May 21, 2018

Subject: Amendment to the Coastal Virginia Offshore Wind Project (CVOW, formerly the Virginia Offshore Wind Technology Advancement Project or VOWTAP) Research Activities Plan (RAP) and Response to Comments

Figure 2. Revised Conceptual Rendering of the Currently Proposed WTG

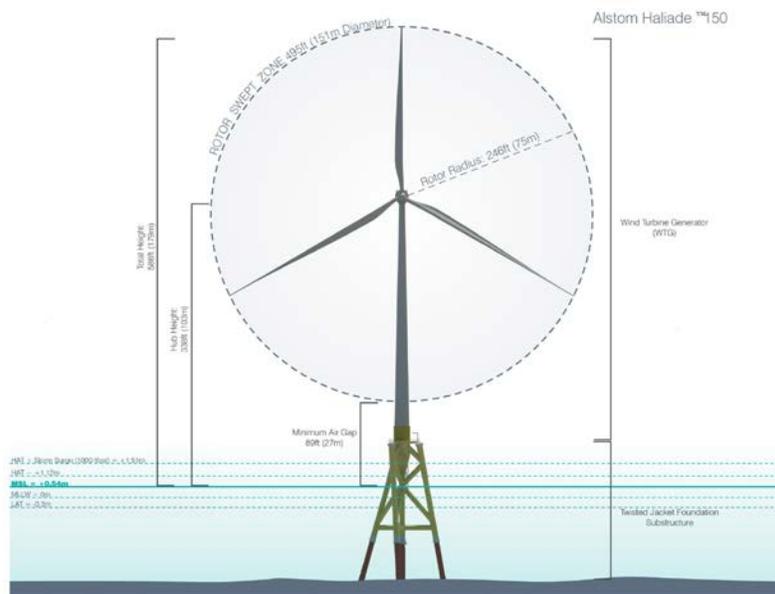
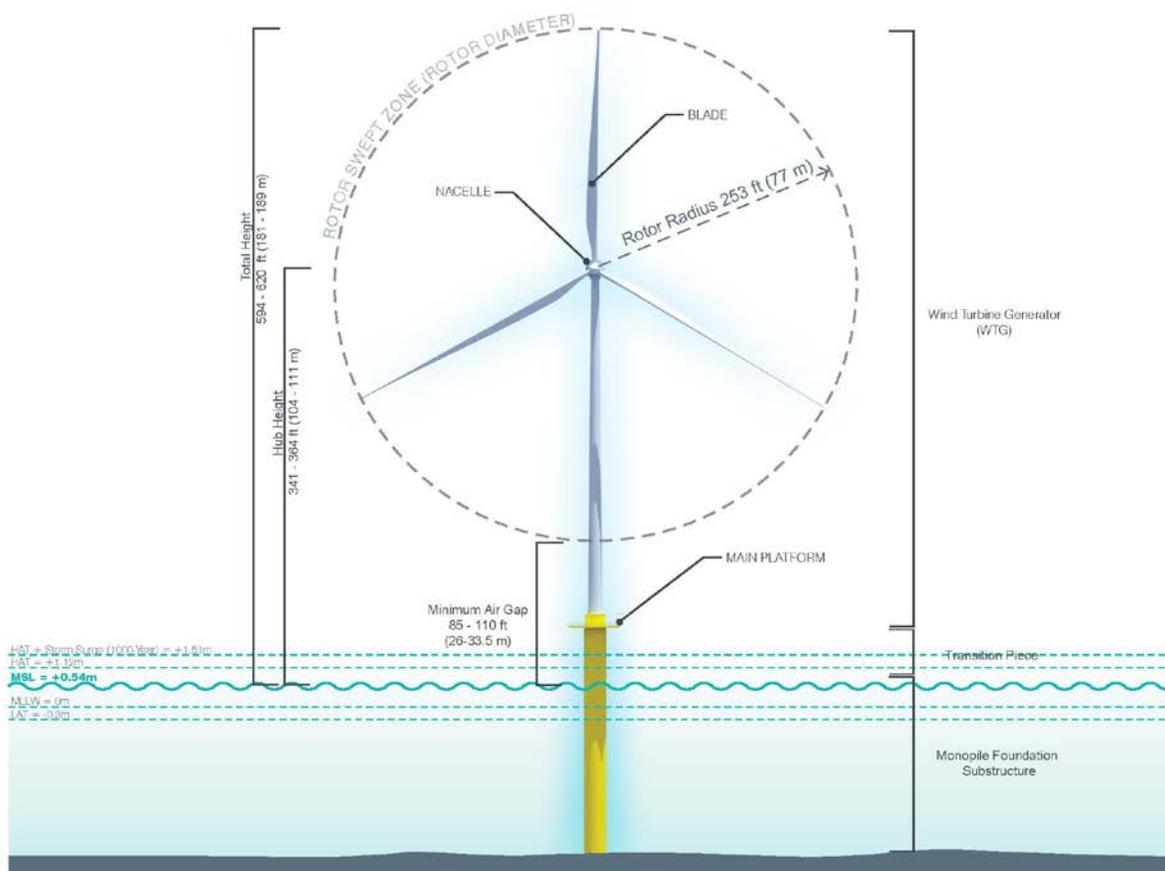
Dominion still intends to deploy two, 6 megawatt (MW) wind turbine generators (WTGs) for the CVOW Project. However, in order to ensure that the best available technology is being utilized for the Project and potentially leverage established market relationships and prior installation experience, Dominion is currently assessing a range of WTG suppliers beyond what was approved in the RAP. As a result, there are some minor changes to the WTG specifications (see Revised Table 3.2-1).

Each of the WTGs will be comprised of a tower, nacelle, rotor, and blades, and will be supported by a monopile foundation (see the following section on the proposed modifications to the WTG foundations). Similar to the Alstom Haliade 150 that was approved in the RAP, the selected WTG will remain a 3-bladed upwind WTG that operates at variable speeds. However, the new WTG will be equipped with Power Boost technology, which is a software enhancement that will enable the WTGs to generate up to 6.3 MW of electricity under certain operational conditions. Power Boost functionality will be governed by certain operational limits such as ambient temperature, internal components temperatures, pitch angles, and wind turbulence level. Figure 1 shows the originally proposed Alstom Haliade 150 WTG as presented in Figure 3.2-1 of the RAP, and Figure 2 shows the revised conceptual rendering of the currently proposed WTGs.

As demonstrated in Revised Table 3.2.1 above, the change of WTG manufacturer results in a minor increase to the overall height and diameter of the WTGs. However, given the distance from shore and curvature of the earth, there will be no change to potential visual impacts associated with the increased WTG height (see Attachment 5 Amendment to the Visual Impact Assessment).

Figure 3. Comparison of IBGS (left) and MP/TP (right) Foundations

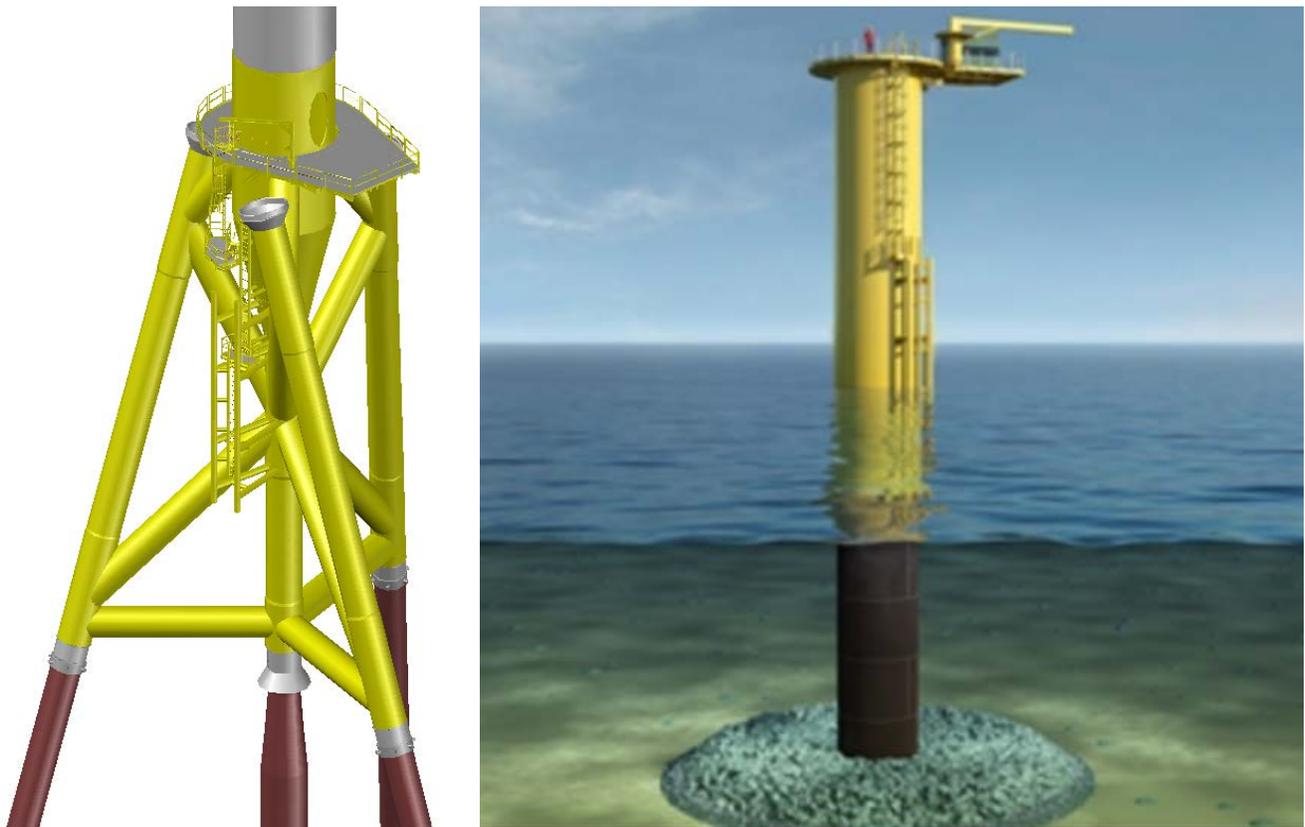
Due to Ørsted’s extensive experience and success with monopile foundations and the advantages of decreased installation time, each WTG will now be supported by a monopile and transition piece (MP/TP) foundation instead of the Inward Battered Guide Structure (IBGS or Twisted Jacket) foundation as described in the approved RAP. The MP/TP foundation consists of a monopile, which is the lowest part of the foundation, and a transition piece, which is mounted on the monopile once the monopile has been driven into the seabed. See Figure 3 for a comparison of the IBGS and MP/TP foundations.

The monopile is primarily a cylindrical steel pile, with an upper conical section that shrinks the pile diameter to fit with the transition piece and WTG tower diameter. The monopile is connected to the transition piece by means of a bolted flange connection.

Figure 4. Generic section view of scour protection (for illustration)

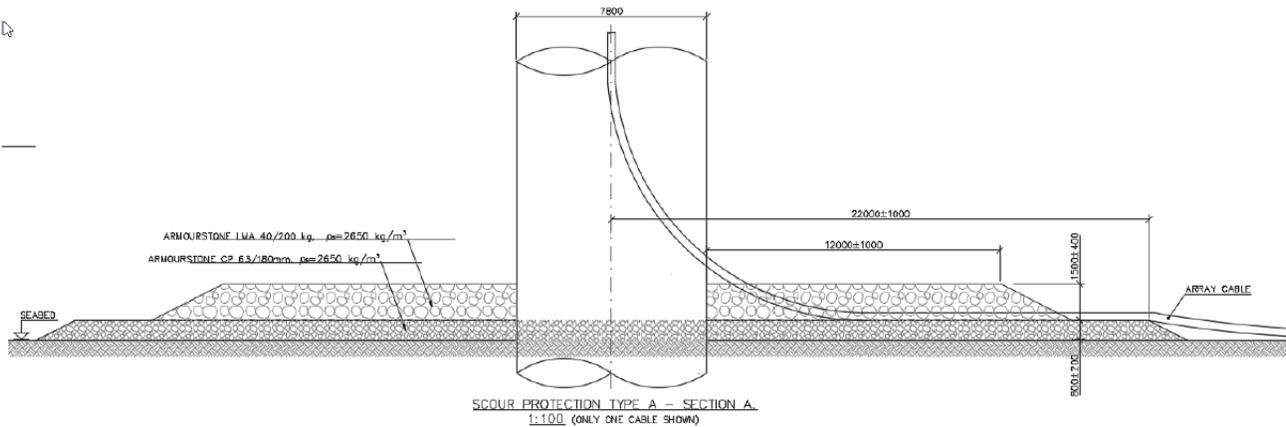
Due to the larger diameter of the monopiles, as compared with the individual diameters of the central caisson and pin piles of the IBGS, there is an increased potential for scour, and as such, the MP/TP foundations will require scour protection. The scour protection system will consist of a preinstalled filter layer of crushed rock material deployed in a radius of approximately 72.2 ft (22 m) and a height of about 2.6 ft (0.8 m) at each foundation location (Figure 4). This layer will be deployed prior to installation of the MP/TP foundations. The second layer, also referred to as the “armor layer,” will be installed on top of the filter layer once the monopile is installed, and the Export and/or Inter-Array Cable(s) have been pulled through. The armor layer consists of crushed rock material weighing between 88.2 lb to 440.9 lb (40 kg and 200 kg), installed in a radius of approximately 39.4 ft (12 m) and a height of about 4.9 ft (1.5 m) around each foundation. Please see the Amendment to the Marine Archaeological Resources Assessment, provided as Attachment 3 to this amendment, for the QMA’s assessment of marine archaeological resources in relation to the foundation, scour protection, and installation.

After installation of the foundations, an initial local scour survey will be conducted within 6 months of commissioning. Subsequent surveys will be conducted at regular intervals after commissioning and after a major storm event. Monitoring will be carried out by multibeam sonar soundings. Should scour holes develop within 10 percent of the local scour design values, additional monitoring and/or mitigation will be performed. Mitigation measures may include the infilling of the scour hole with an appropriate crushed rock fill, or the use of frond mats or other proven systems to minimize/reverse future scour. The specific need, type, and method of additional scour protection will be determined in consultation and coordination with relevant jurisdictional agencies prior to deployment.

Figure 5. Comparison of Onshore Route Approved in RAP and Proposed New Onshore Route and Alternatives

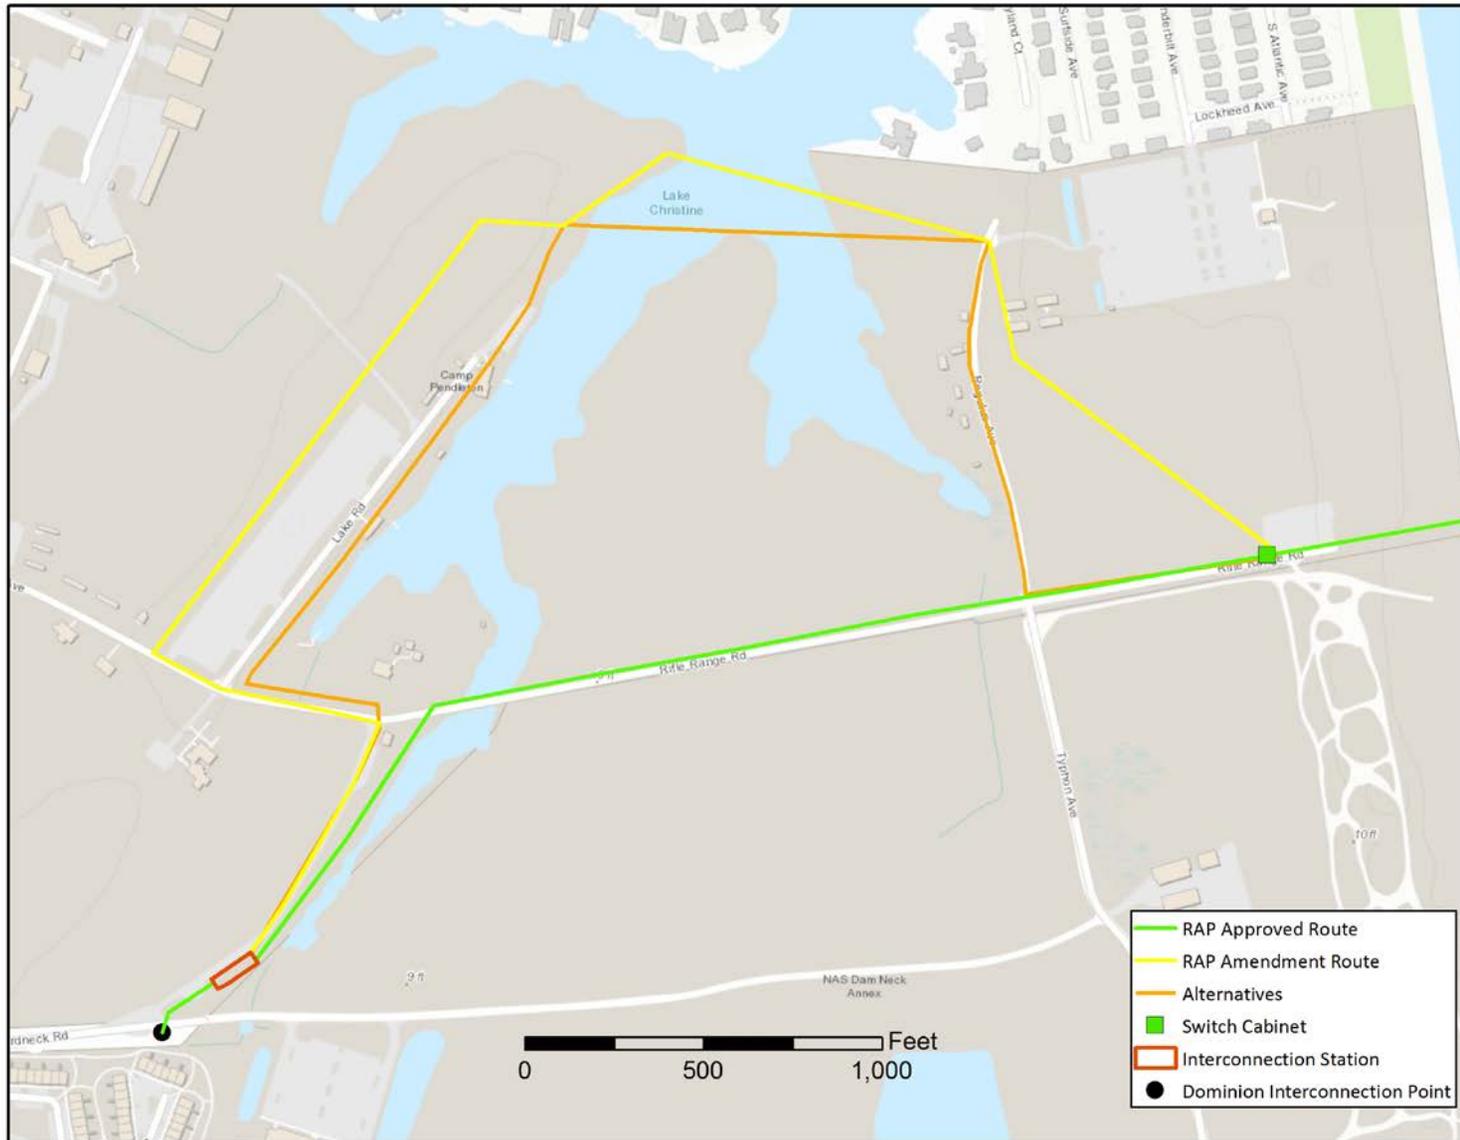
Due to new, previously unknown conflicts with military activities, Camp Pendleton is requiring a modification to the previously approved Onshore Interconnection Cable Route which is required to support the construction and operation of both the Onshore Interconnection Cable and Fiber Optic Cable. The portion of Rifle Range Road from

The modified Onshore Interconnection Cable Route will originate at the proposed Switch Cabinet located within an existing parking lot at the end of Rifle Range Road and adjacent to Camp Pendleton Beach, as previously identified in the approved RAP. The modified cable route then extends in a northwest direction through the rifle range for a distance of approximately 900 ft (274 m) to the northwest corner of the rifle range, just south of a canine training area. The modified cable route then extends in a generally northern direction for a distance of approximately 335 ft (102 m) to a gravel turnaround area, which will serve as an equipment laydown and staging area for the HDD under Lake Christine. From the staging area, the HDD under Lake Christine will be approximately 935 ft (285 m) long and will run in a west/northwest direction under Lake Christine to the cleared area on the western side of the lake, which will act as the HDD staging area for the HDD punch-out. After the Lake Christine crossing, the cable route turns to the southwest, for approximately 350 ft (107 m) through a previously disturbed area. The temporary work space associated with each HDD staging area on either side of Lake Christine will be located within the 30 ft (9m) temporary workspace.

Alternatively, Dominion may elect to locate the Onshore Interconnection Cable Route beginning at the Switch Cabinet extending in a west-south-west direction along Rifle Range Road for approximately 700 ft (213 m) until reaching the intersection of Rifle Range Road and Regulus Avenue. At the intersection of Rifle Range Road and Regulus Avenue, the Onshore Interconnection Cable Route extends in a general northerly direction for approximately 1000 ft (305 m) until reaching the gravel turnaround area, which will serve as an equipment laydown and staging area for the horizontal directional drill (HDD) under Lake Christine. The HDD under Lake Christine for this alternative will be approximately 1200 ft (366 m) long and will run in a generally west direction to a

previously disturbed area located approximately 350 ft (107 m) southwest the cleared area on the western side of the lake. Regardless of which HDD crossing is selected, the temporary work space associated with each HDD staging area on either side of Lake Christine will be located within the 30 ft (9m) temporary workspace.

Additional information in response to comment 11 above

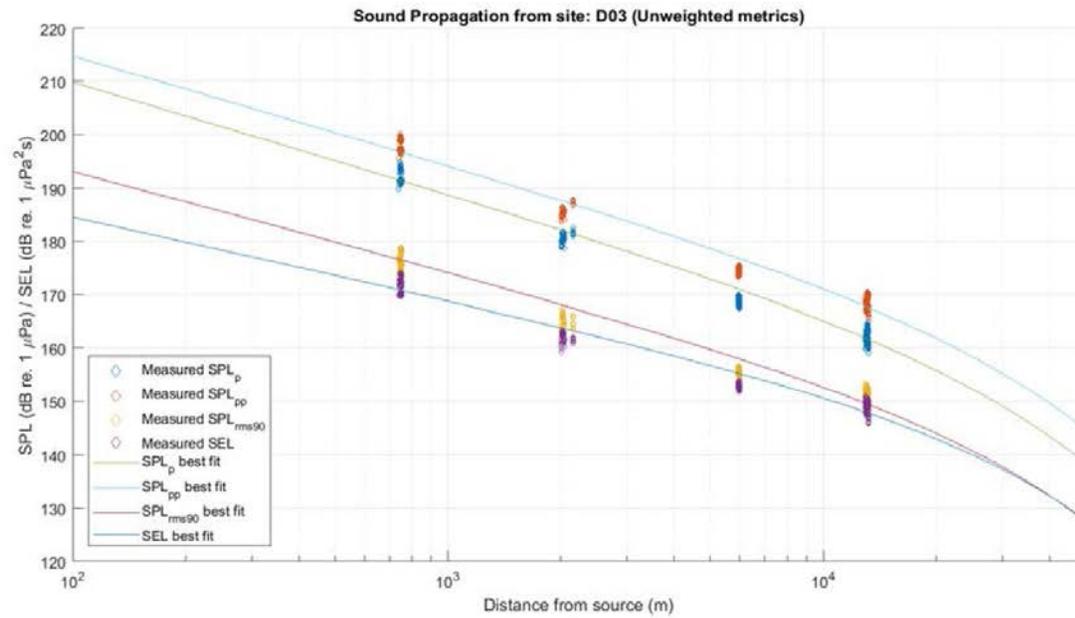
Sound transmission loss curve fit for all relevant metrics, based on recorded pile strikes during installation at D03, adjusted to maximum hammer energy (3500 kJ).
